Re: East Fork of Box Canyon undermining modification to the approved Resource Recovery and Protection Plan (R2P2) for Federal Coal Lease UTU-76195

Re: Approval of Mining Underneath Box Canyon in the 3rd and 4th Left Panels, Minor Modification to the Resource Recovery and Protection Plan (R2P2), Federal Coal Lease UTU-76195

Worksheet
Documentation of Land Use Plan Conformance and NEPA Adequacy (DNA)

Proposed Action Title/Type: Minor Modification to an approved Resource Recovery and Protection Plan to fully extract coal underneath a 143.25 acre portion of the East Fork of Box Canyon Creek Drainage.

Map 1 Project Area Geology

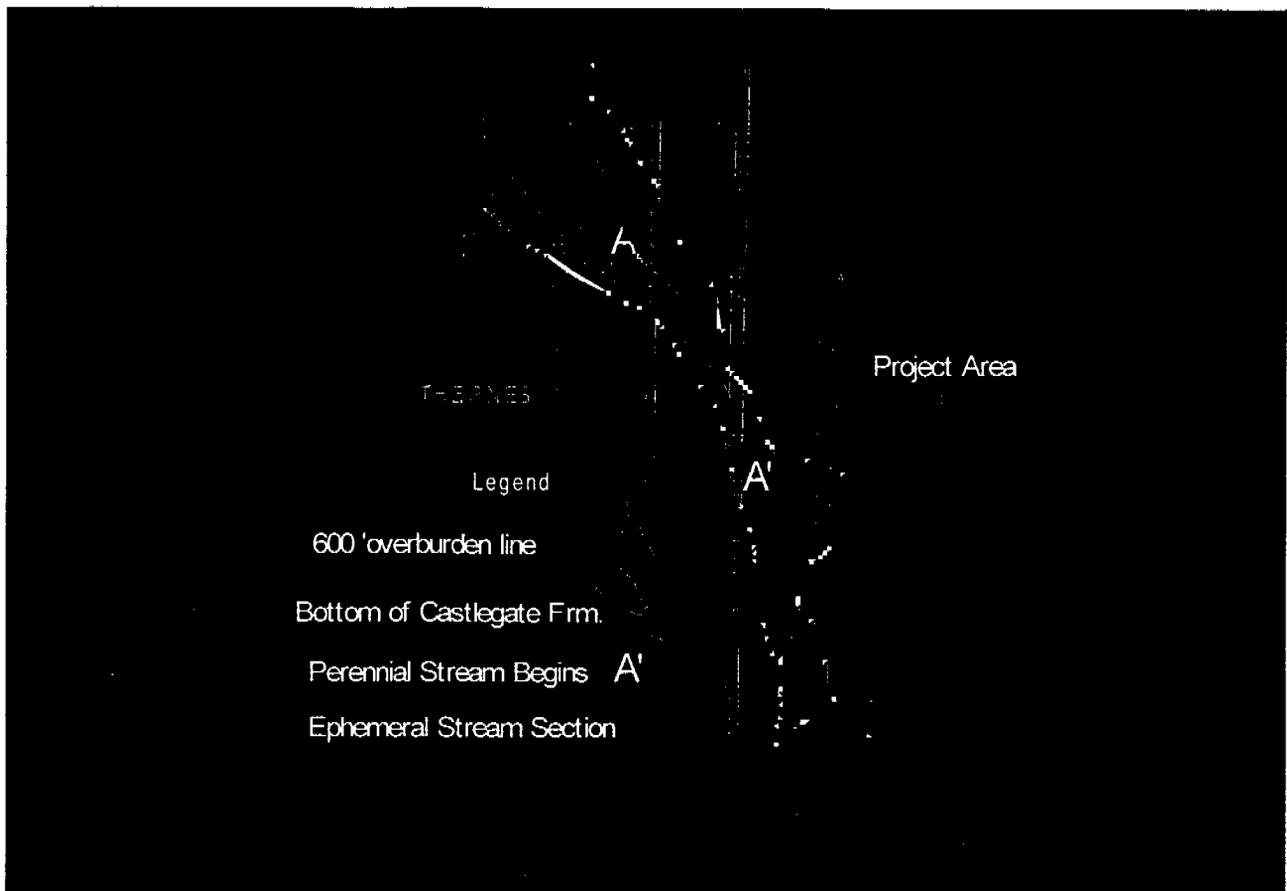
The proposed action of mining under the East Fork of Box Canyon was analyzed in the Final Environmental Impact Statement for the Pines Tract Project. The issue is undermining and subsiding the perennial and "perennially functioning" (ephemeral) portions of the East Fork of Box Canyon. The issue is subsidence of the East Fork of Box Canyon creek. In the first longwall panel (3rd Left) the stream is mainly in the Blackhawk formation and is perennial for the entire length of the panel. In the second panel the stream is in the Castle Gate formation and is

only perennial for a small portion of the drainage length. In the third longwall panel only has two small stock ponds in the area. When an area is subsided, two types of surface cracks can occur. Transient cracks that form parallel to the longwall face and cracks that form perpendicular to the longwall face over the gateroads. Both types of cracks are relatively shallow surface features and have been observed in the field to extend to depths of generally less than 30 feet. The limited cracks that occur in the bottom of drainages appear to close relatively quickly and fill up with sediment and other debris. Cracks that occur in the bottom of the streams could temporarily interrupt streamflow, but flow would resume once the cracks have filled with water or organic material. If this natural mitigation does not occur in a timely fashion, then the the stream flow could be restored sooner by placing material in the stream channel. The FEIS discussed this issue at great length and addressed potential impacts and mitigation as follows:

Figure 1 MSO 2002 and 2003 Survey Area

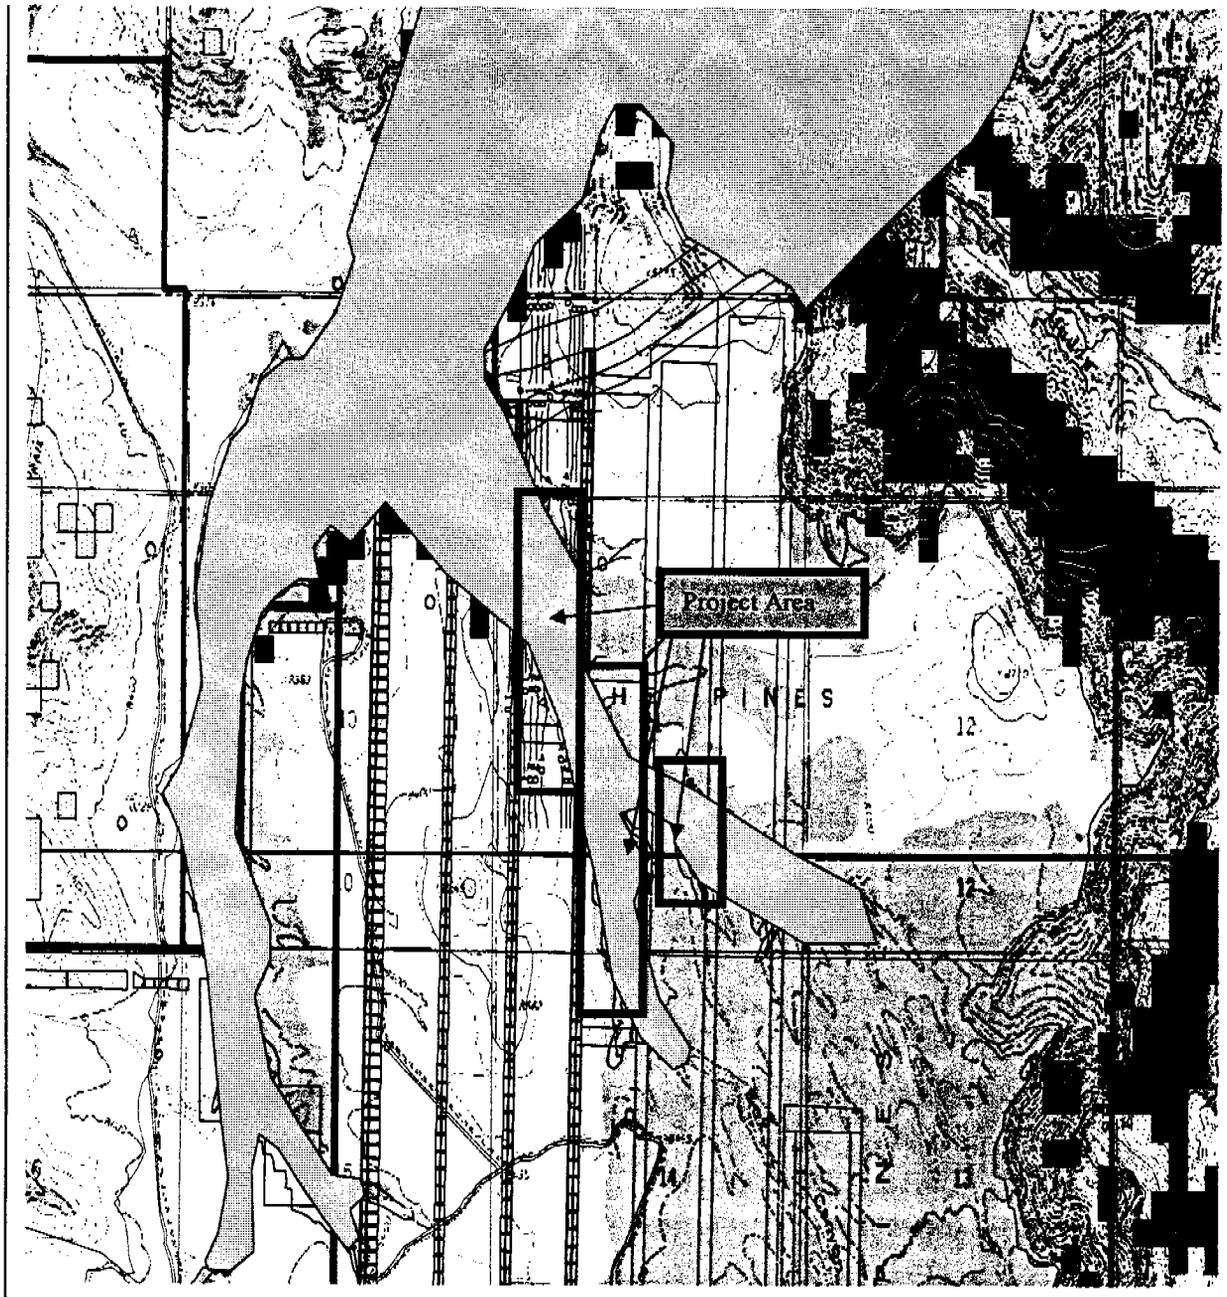
MSO surveys have been conducted in and around the project area according to the Fish and Wildlife Service protocol, under contract from the Manti LaSal National forest. Four surveys were conducted in 2002 and one survey has been conducted in 2003. So far no owls have been found. Three remaining surveys will be completed by late Aug 2003.

Because the impacts have already been analyzed for raptors and disclosed to the public, and the MSO were not found in the 1997 or subsequent surveys, no additional NEPA analysis or public notification is necessary because the impacts listed in the FEIS would be the same for the MSO as other raptors. BLM informally consulted with Fish and Wildlife Service on June 30, 2003. The FWS does not oppose having the project go forward based on the information gathered to-date on the MSO. The FWS requests that the remaining MSO surveys take place. If
